Niagara Mohawk Power Corporation

License No. DPR-63

Docket No. 50-220

Proposed Changes to Technical Specifications (Appendix A)

FIGURE 1

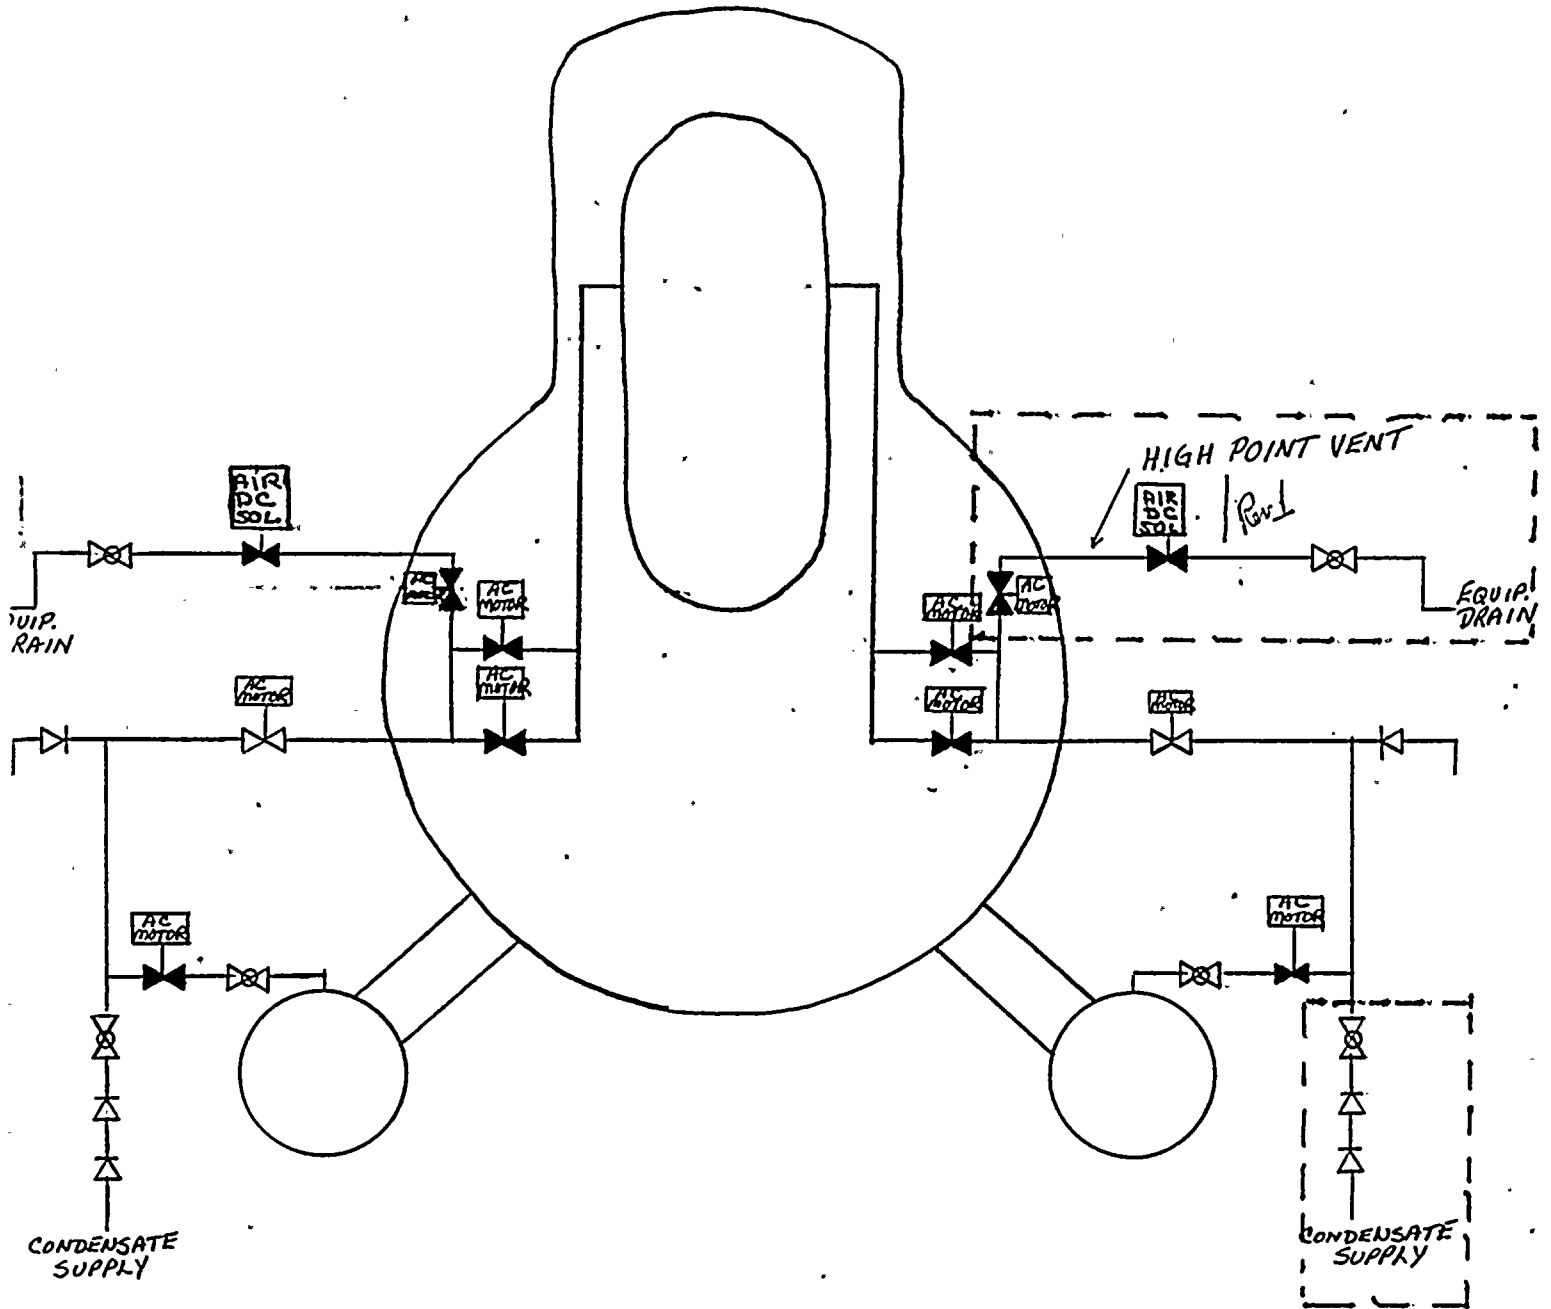
A modification will be made to the core spray system at Nine Mile Point Unit 1 during the spring 1981 refueling outage. The modification consists of a high point vent, a keep fill system and isolation valves as shown on Figure 1. The purpose of this modification is to eliminate the need to shutdown the reactor to perform the quarterly core spray valve operability test.

During normal operation, the high point vent system is isolated and the core spray high point vent isolation valves are normally closed. Prior to the quarterly core spray valve operability test and at other times deemed necessary, the two high point vent valves would be opened. Verification of flow to the equipment drain tank would assure the core spray system piping was filled up to the inside core spray isolation valve. The high point vent valves would then be closed and the inside core spray valves operated.

This modification will require the addition of two core spray high point vent isolation valves on each core spray line. These valves will be closed during normal operation. Automatic isolation is also provided.
